Technical Bulletin

TB 0300 - Emergency Showers & Eyewash Systems In Transmission & Zone Substations

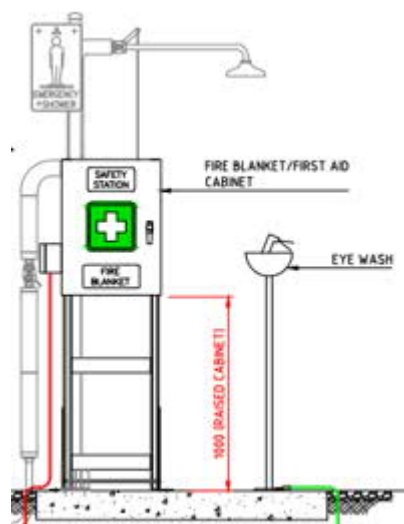
tissue damage caused by fire or hazardous chemical spills. One of the safety improvements, as an outcome of these consultations, was to introduce a safety station which includes a combine deluge shower/ eye wash/ fire blanket/ medical emergency button (note that this medical emergency button is in addition to the button which is normally located in the control room). This safety station will be located adjacent to the front parking area and the proposed design is shown as follows:

It was also decided to install additional deluge showers if:

- Required to traverse stairs higher than 800mm.
- Required to traverse further than a 60m radius to high voltage equipment located in a switchyard.
